## Liverpool Hospital Redevelopment Stage 2.1

## Preferred Project Report

Liverpool Hospital Redevelopment Stage 2.1 (MP08\_0036)

Fig 2.01 - Staging Plan

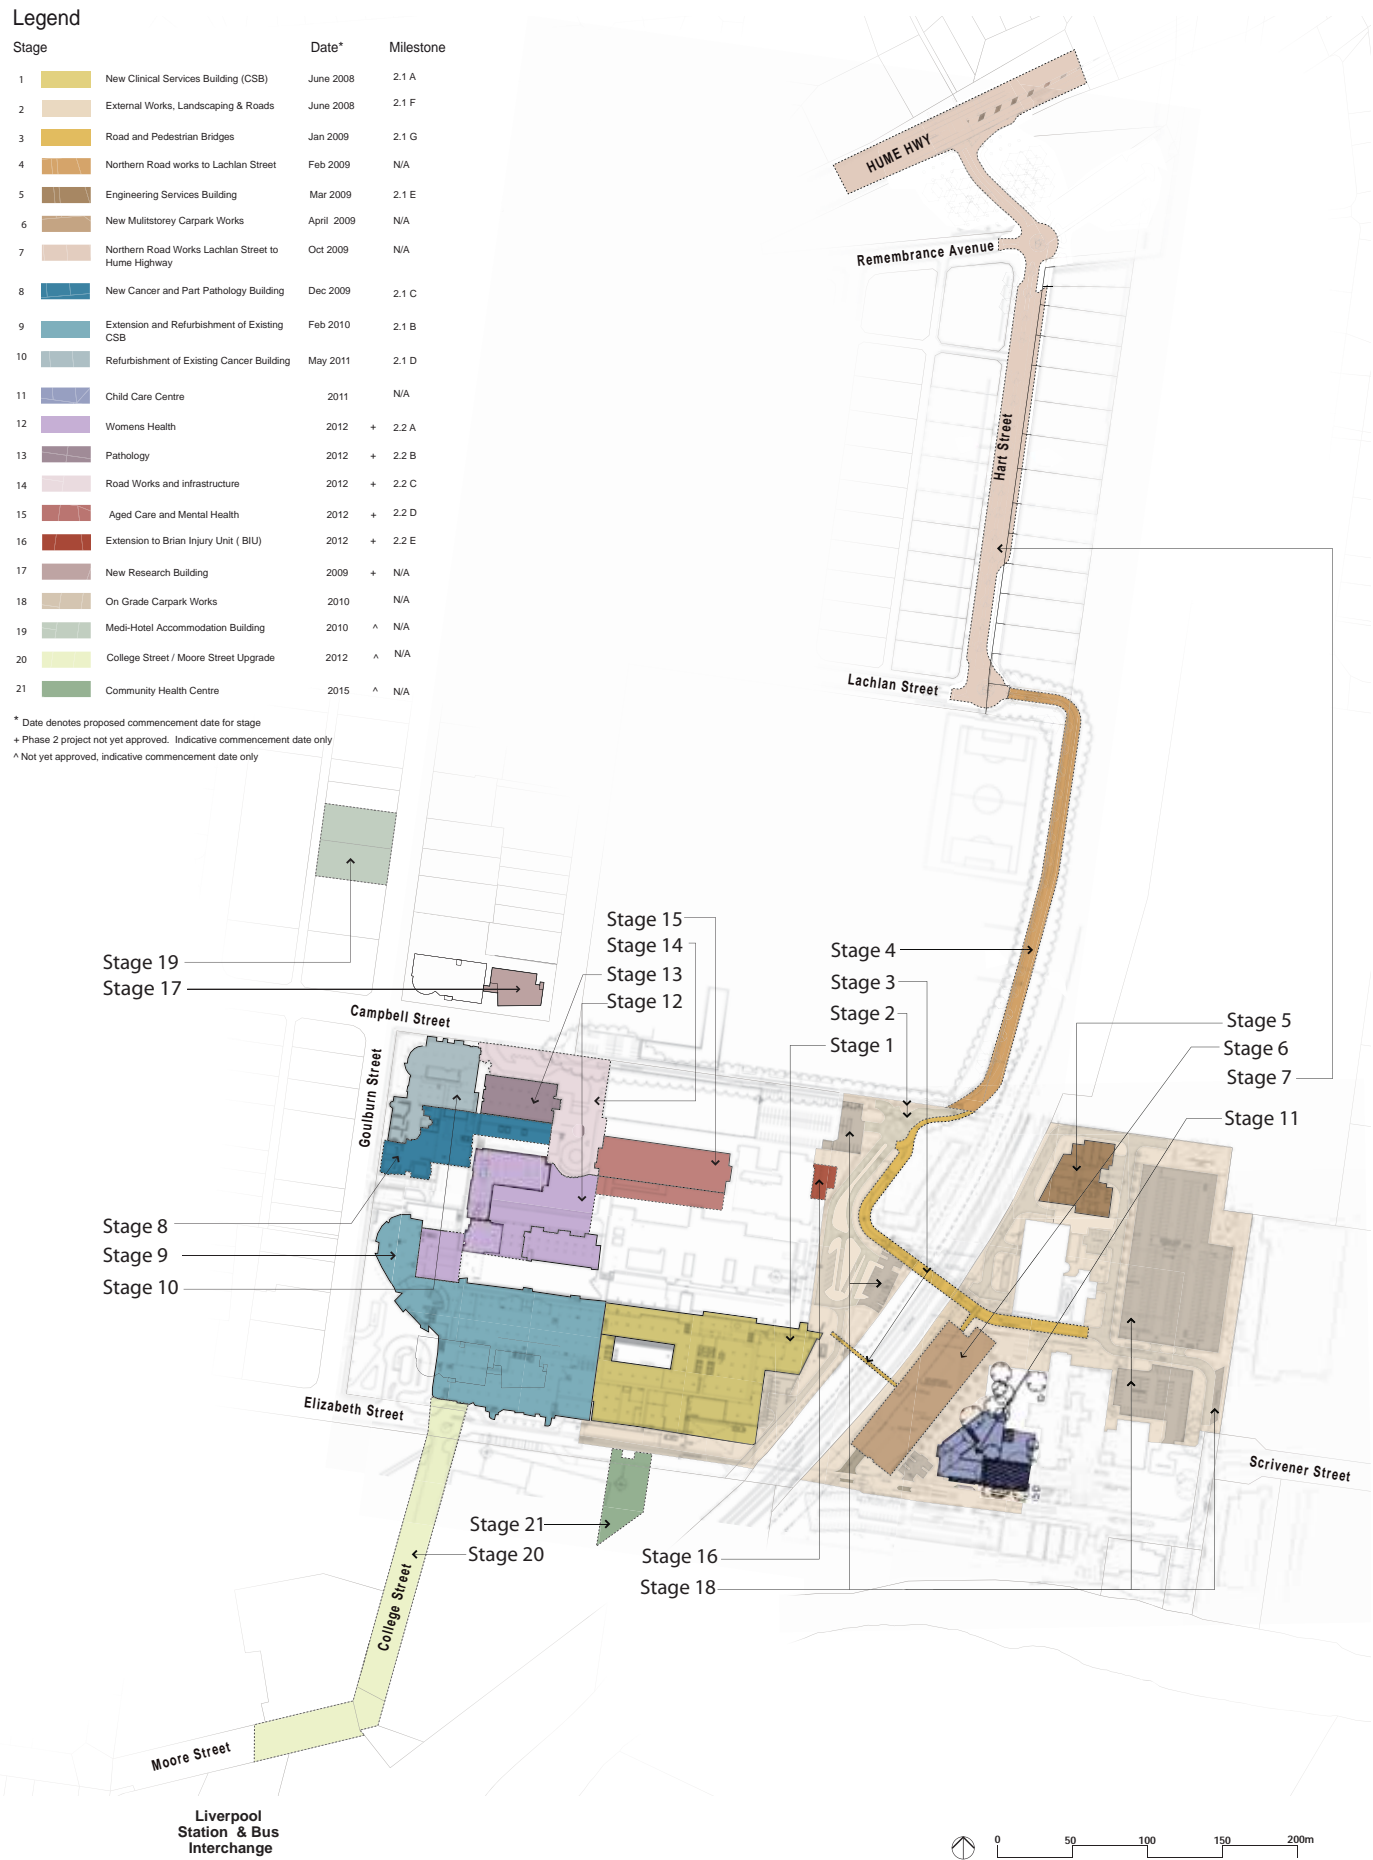
| Issue            |  | Response   |  |                               |
|------------------|--|--|--|-------------------------------|
| Staging          | Concerns have been raised regarding the numbering of the staging program (ie. Stage 2.1A, 2.2A, 2.2B etc). As a result, it is requested that a revised staging plan is provided to simplify the numbering system for the staging of development on the site, in order to reduce confusion for the public (ie. Stage 2, 3, 4, etc). Target dates for each of the stages should also be updated. | A revised staging plan (refer fig. 2.01) has been prepared addressing all of the components identified in the approved Concept Plan. The commencement dates for the first 11 stages have been defined. The target dates for Phase 2 of the project are indicative. It is anticipated that the staging plan will be subject to revision and form part of subsequent Project Applications. |  |                               |

Fig 2.03 - Construction Traffic Management

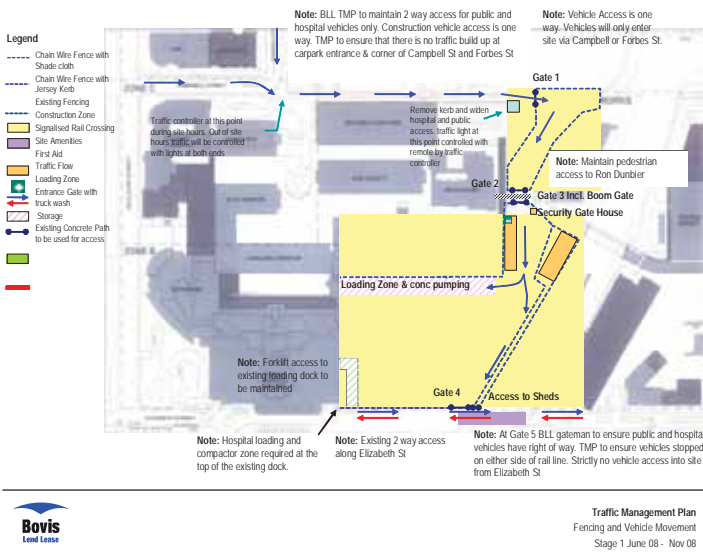
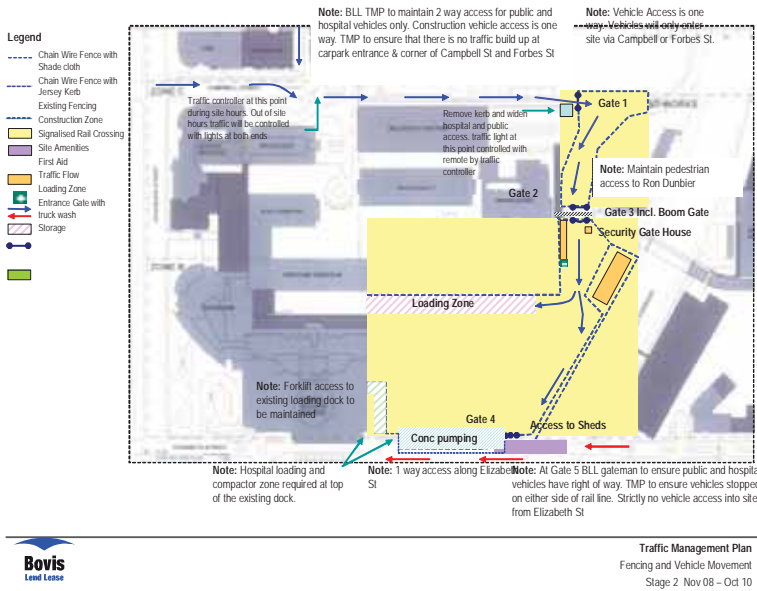
| Issue  | Response   |
|--|--|
| <p><b>Access and Traffic</b></p> <p><i>With regard to the northern access road to be constructed, at construction, vehicles and traffic is to enter and leave the site via the new access road from this when completed. Until such time vehicles are to enter and leave the site in accordance with the Management Plan Figure 5:14 as stipulated in the EA.</i></p> <p><i>Due to the number of schools located in the immediate area of the hospital council is concerned with the amount of traffic during school peak times. It is therefore requested that construction traffic not use the following roads between 8:30am and 9:30am and between 2:30pm and 3:30pm on school days, due to school and pedestrian traffic:</i></p> <ul style="list-style-type: none"><li><i>Forbes St between Campbell street and Lachlan Street,</i></li><li><i>Campbell Street between George Street and Bigge street, and</i></li><li><i>Bigge Street between Campbell Street and Elizabeth Street.</i></li><li></li></ul> <p><i>The EA and supporting documentation does not identify an area for car carparking for workers during the construction stage of the development. Due to the lack of on-street car parking in the immediate and surrounding area, it is suggested that an area be set aside to cater for construction workers vehicles.</i></p> | <p>Bovis Lend Lease has developed ‘Traffic, Parking Management and Vehicle Movement Plan’ as part of ‘Environmental Health and Safety Plan’ submitted in the project application.</p> <p>The vehicle movement plan stipulates vehicle delivery routes and procedures for movement in the vicinity of the site – as illustrated by the attached LHR Delivery Map.</p> <p>Restricting movement in Forbes Street between the hours of 8:30 and 9:30 and between 2:30 and 3:30 would impose significant constraint on the construction process with potential to compromise construction programme and budget.</p> <p>Bovis Lend Lease have consulted with the schools and implemented traffic management measures, including traffic controllers, to minimize the impact of construction traffic.</p> <p>Bulk excavation on the site has been carried out in the past three months and material removed using traffic routes indicated on the LHR Delivery Plan. No incidents or complaints were received in this period.</p> <p>Bovis Lend Lease are not proposing to provide carparking for construction workers. The site is well serviced by public transport; two train stations are in close proximity and regular bus routes service the area. BLL are encouraging subcontractors to use public transport and/or arrange for minibus transport to the site.</p> <p>Limited carparking will be provided on site for service vehicles.</p> |

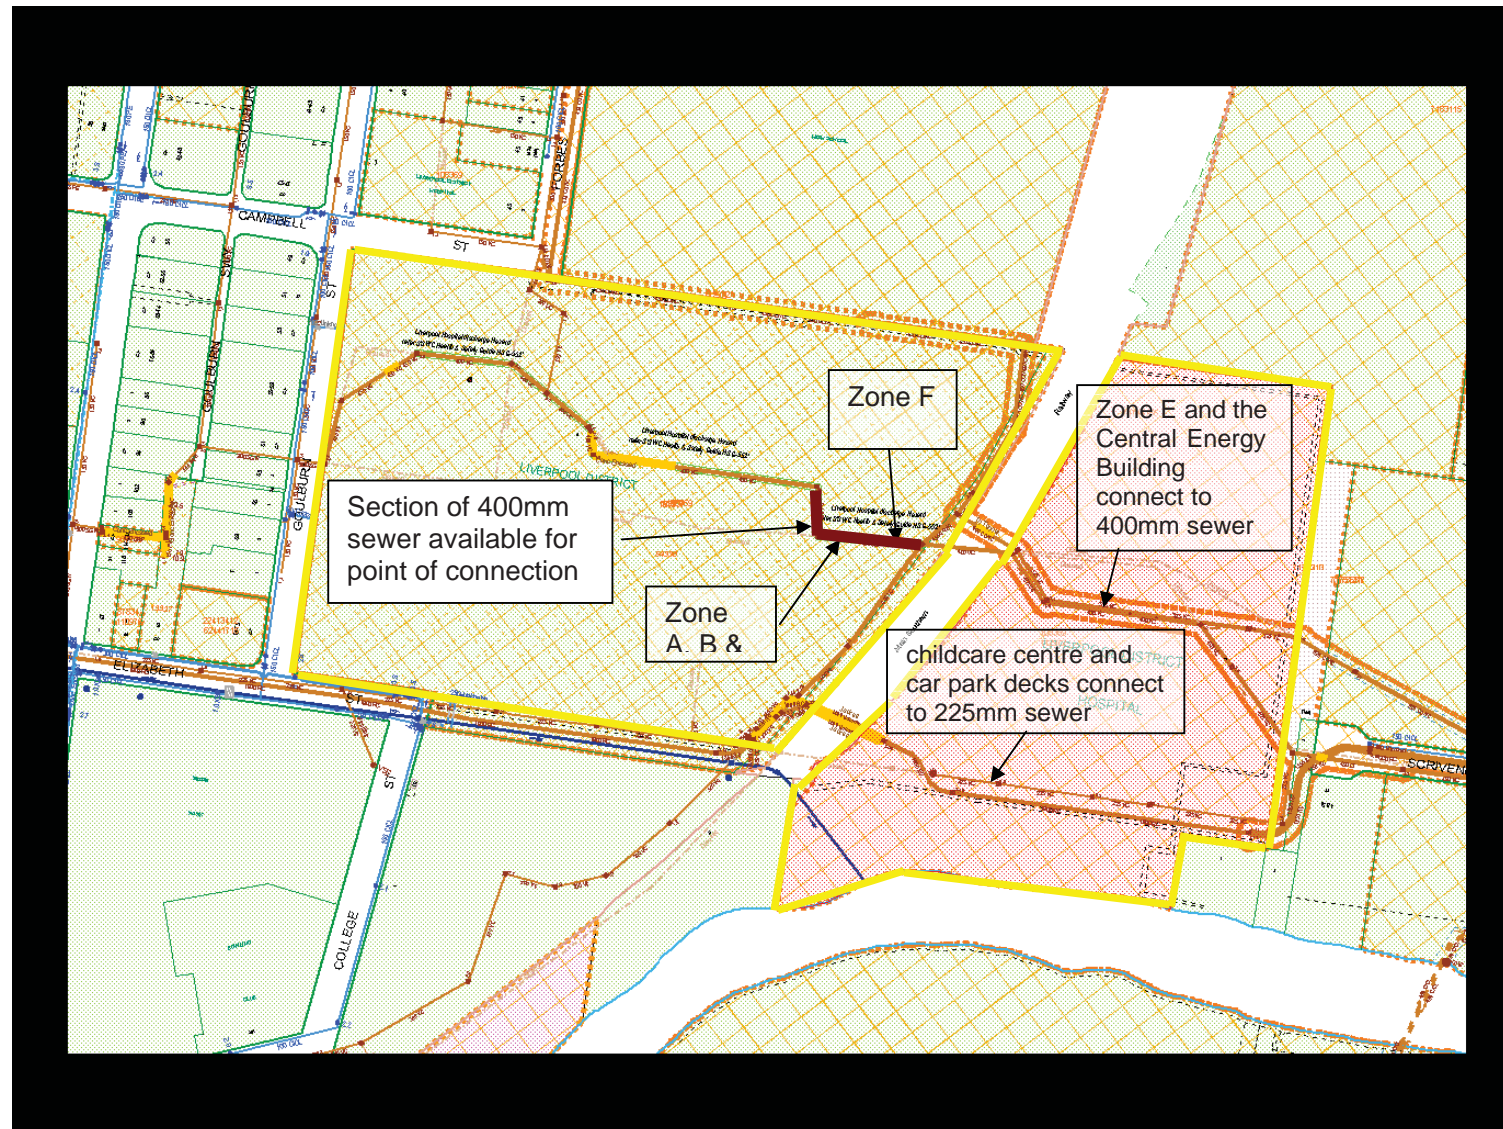
Sydney Water has assessed your application and found that the 400mm sewer which passes through the site on the western side of the railway has insufficient capacity for the development. Connection points are required further downstream. These points are detailed below and in the diagram following.

- The existing 400mm VC sewer main west of the railway will serve Zones A, B, C & F
- The existing 225mm VC sewer main east of the railway, and south of the childcare centre and parking station will serve these buildings.
- The existing 400mm VC sewer main east of the railway and south of Zone E & the central energy buildings will serve Zone E & the central energy buildings.
